ADDENDUM NO. 1

**Campground Loop 4 Upgrades
Montauk State Park
Salem, Missouri
PROJECT NO. X2203-01**

CAMPGROUND LOOP 4 UPGRADES ADDENDUM 1

EXHIBIT
E-100

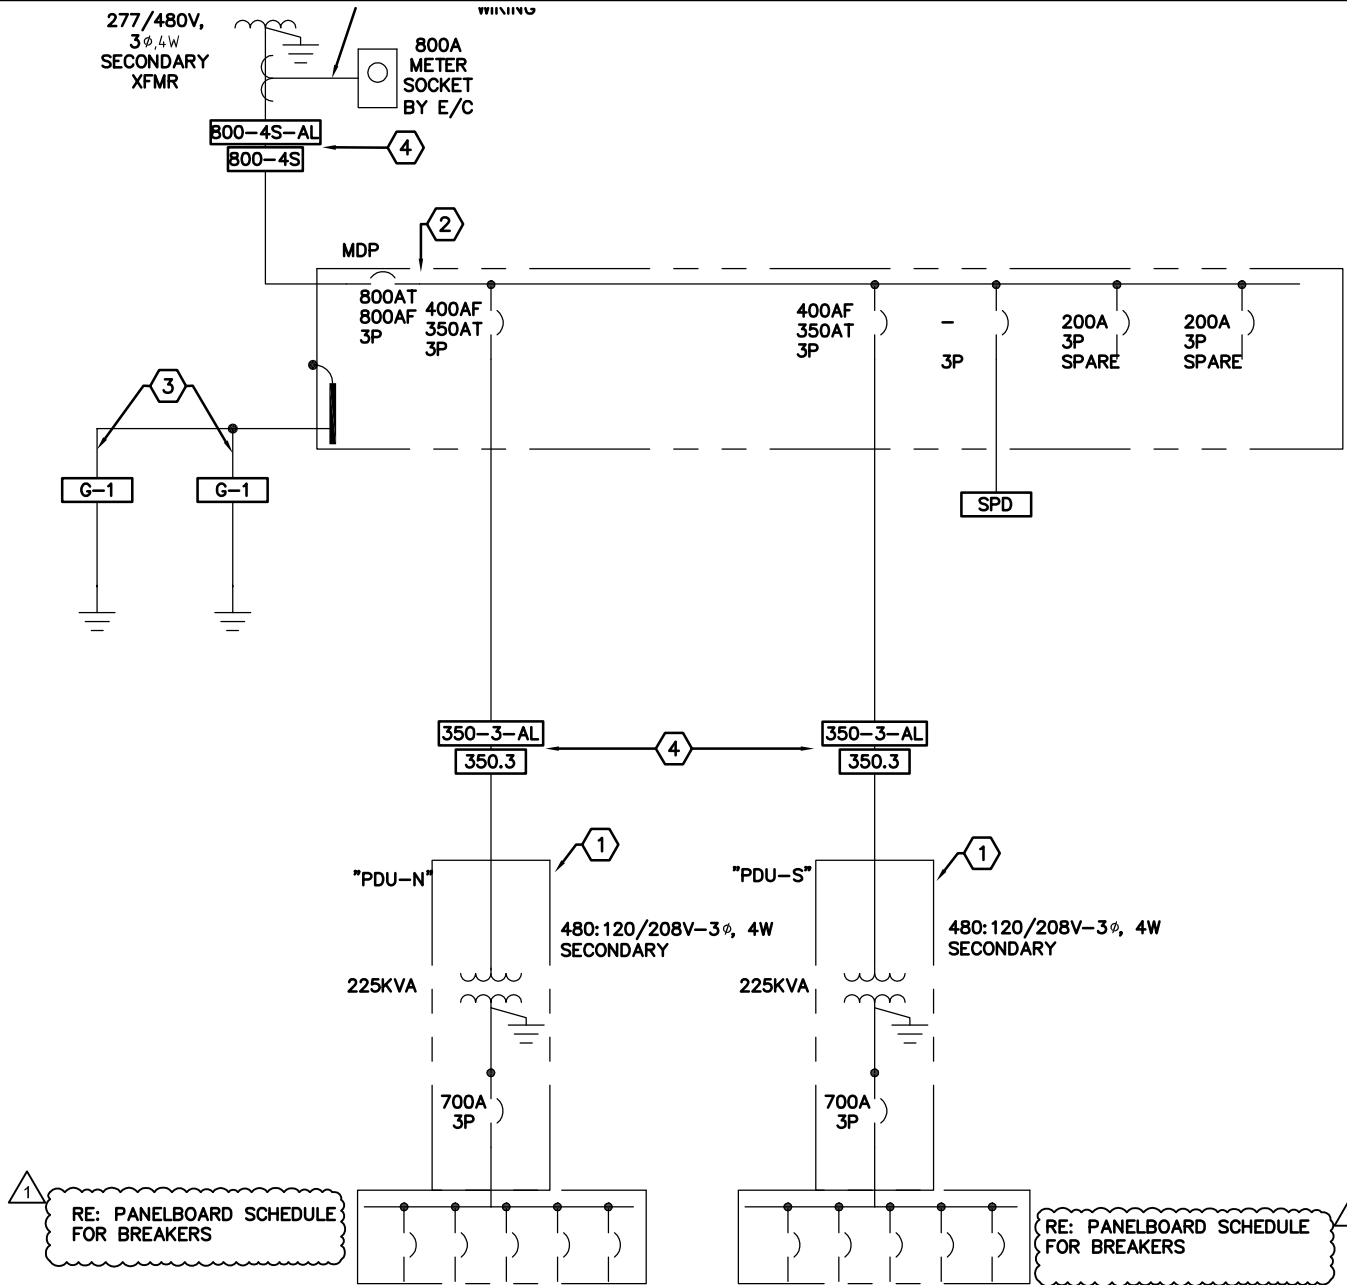
- a. REVISE Site Power Plan per attachment Exhibit E-100.

1 8. UNDERGROUND CONDUITS SHALL BE INSTALLED TO AVOID CROSSING PAVED AREAS AND BENEATH TREE CANOPIES. SAW CUT OR BORE UNDER ROADS FOR UNDERGROUND CONDUIT ROUTING. DETERMINE EXACT ROUTING OF BELOW GRADE CONDUITS TO MINIMIZE ROUTING UNDER PAVED SURFACES AND REMOVING TREES. WHERE EXISTING PAVEMENT IS REMOVED, SAW CUT CLEAN EDGES AND REPLACE WITH CONCRETE PAVEMENT PER THE CAMPSITE CROSS SECTION ON SHEET C-400.
